Attached is a copy of a report dated February 17, 1988, from the Federal Emergency Agency (FEMA) evaluation of the Waterford 3 Steam Electric Station alert and notification system. The FEMA representatives conducted a system engineering design review and a telephone survey of persons living in the vicinity of the Waterford 3 site. The attached document titled "Waterford 3 Steam Electric Station Site Specific Offsite Radiological Emergency Preparedness Alert And Notification System Quality Assurance Verification " concluded that there was reasonable assurance that the system was adequate to promptly alert and notify the public in the event of a radiological emergency at the site. The Honorable Buddy Roemer, Governor of Louisiana, has been advised of the approval.

The Federal Emergency Management Agency (FEMA) has completed an analysis of the prompt alert and notification system for the Waterford III Steam Electric Station located in Taft, Louisiana. This review has been completed pursuant to Title 44 CFR, Part 350; selected evaluative criteria and Appendix 3 in NUREG-0654/FEMA-REP-1, Revision 1; and FEMA-REP-10, the "Guide for the Evaluation of Alert and Notification Systems for Nu

COMPOSITE REGRESSION, DESIGN REPORT (WS3000 SIREN)

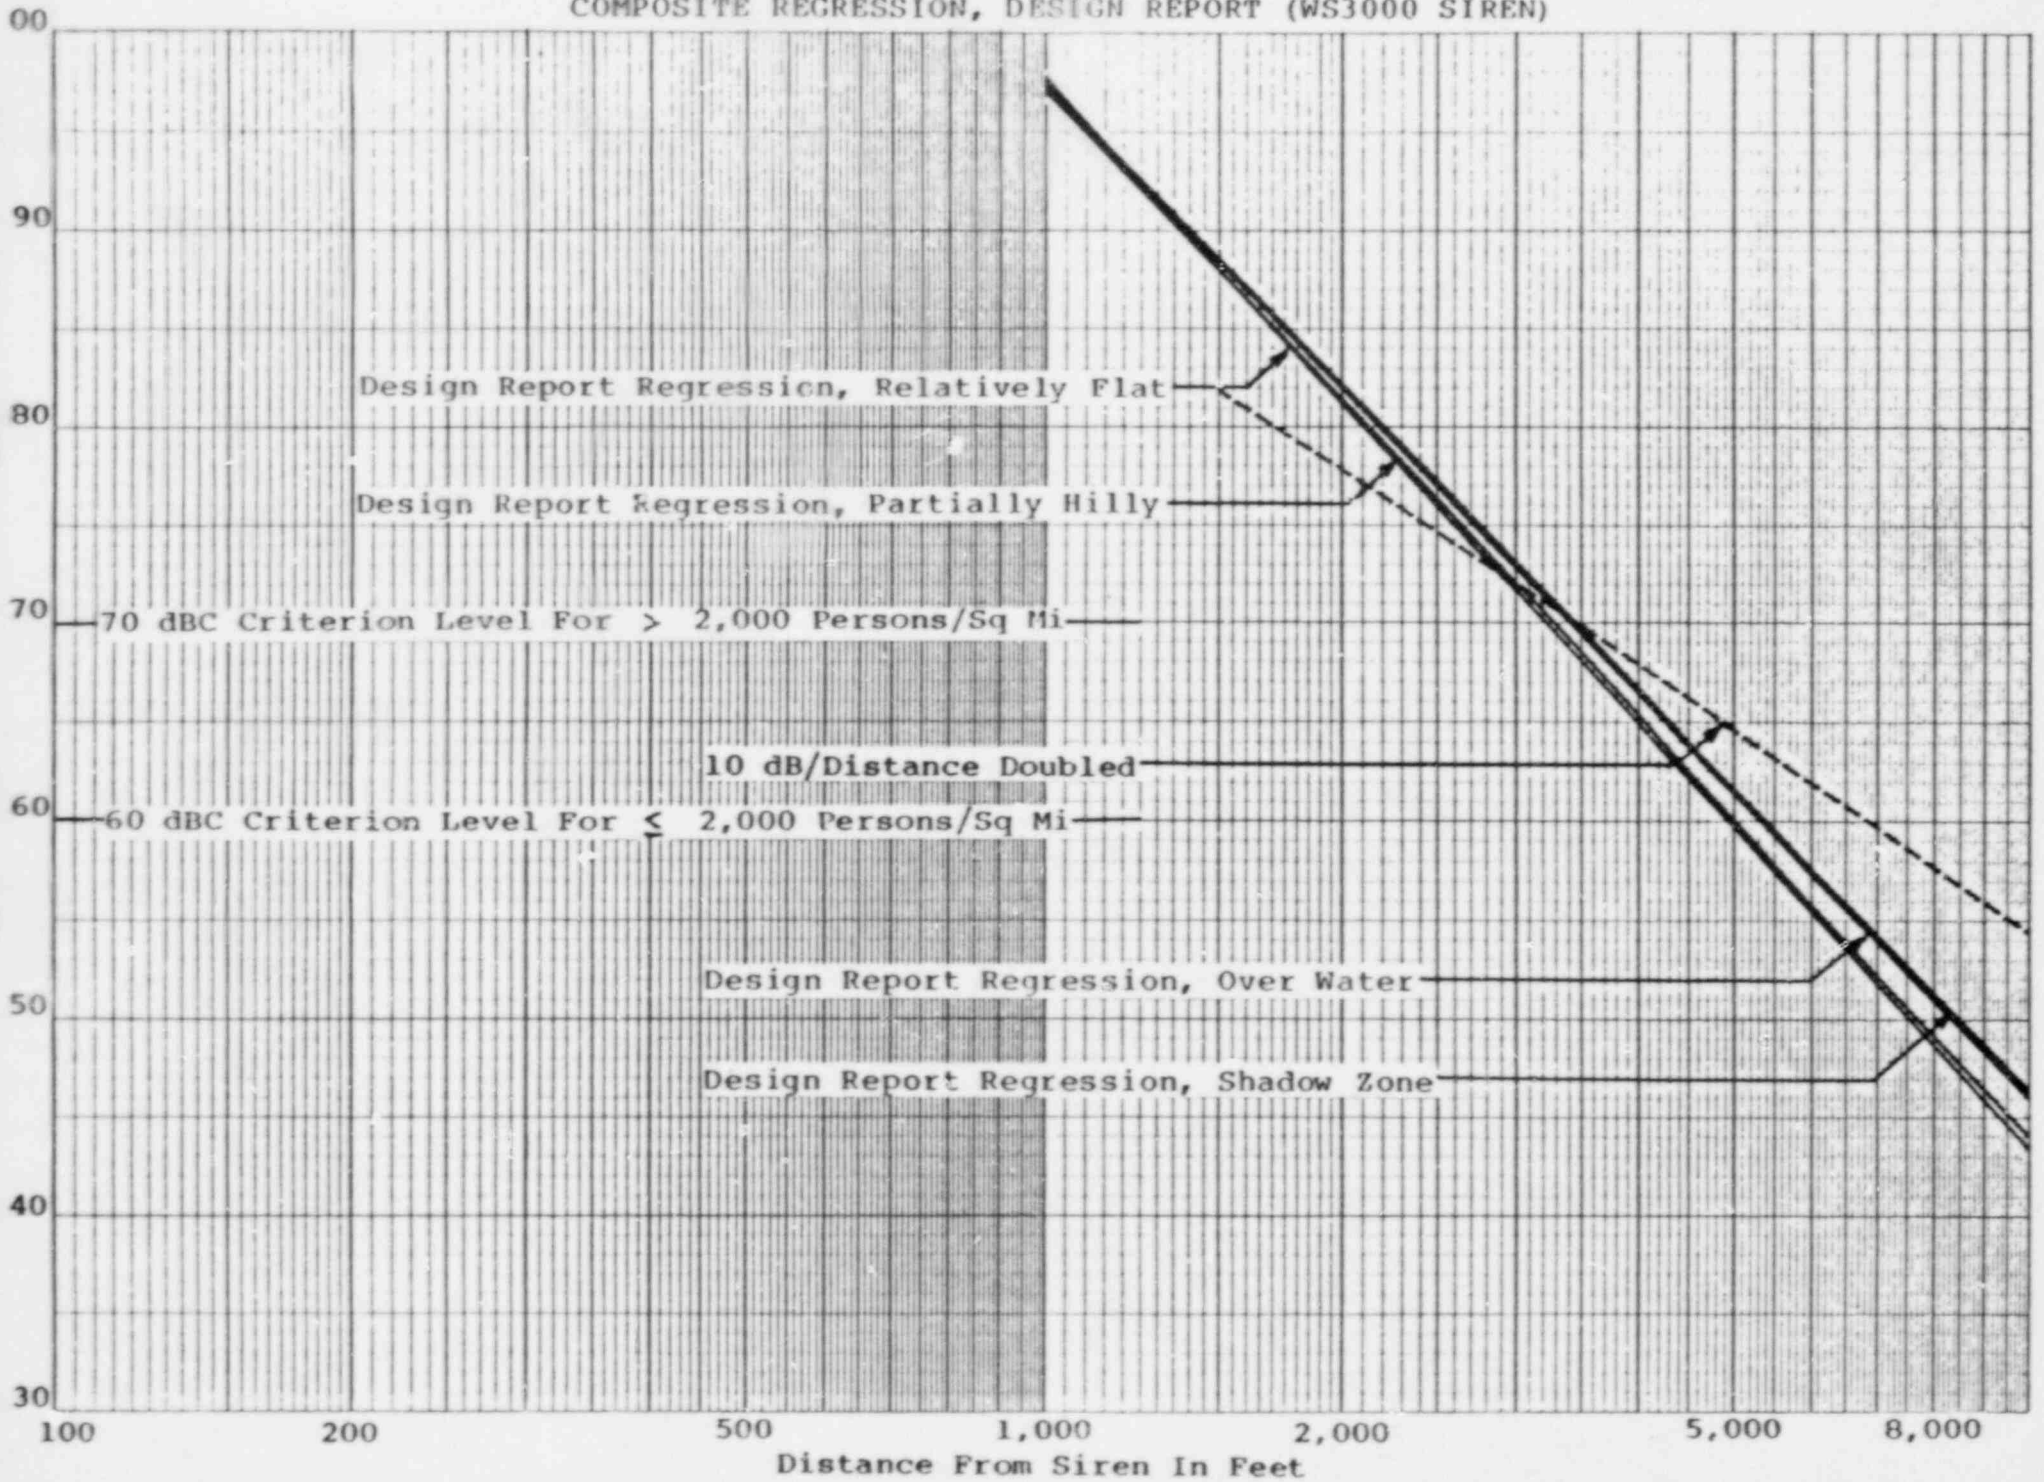
Figure 2 of this report shows the regression data of the Design Report's computer model prediction results for all categories characteristic of the site. The 10 dB loss per distance doubled attenuation rate is also included in Figure 2 for comparison. The Design Report's computer model predictions for these 15 sirens yield an apparent sloping rate of 15 dB loss per distance doubled within 1,000 to 10,000 ft from the siren (with 7 to 10 dB loss per distance doubled within 1,000 ft). The Design Report's results do not seem to consistently reflect the influence of site terrain conditions. As shown in Figure 2 of this report, the regression lines of the Design Report's predicted siren sound pressure levels in the upwind direction and those over water are virtually identical, and differ very slightly (within 2 dBC) with those over the two terrain categories. This is contrary to the expected behavior of a severe attenuation rate in upwind shadows, a moderate attenuation rate over rolling terrain, a decreasing rate over flat terrain, and the smallest attenuation rate over the reflecting surface of water.
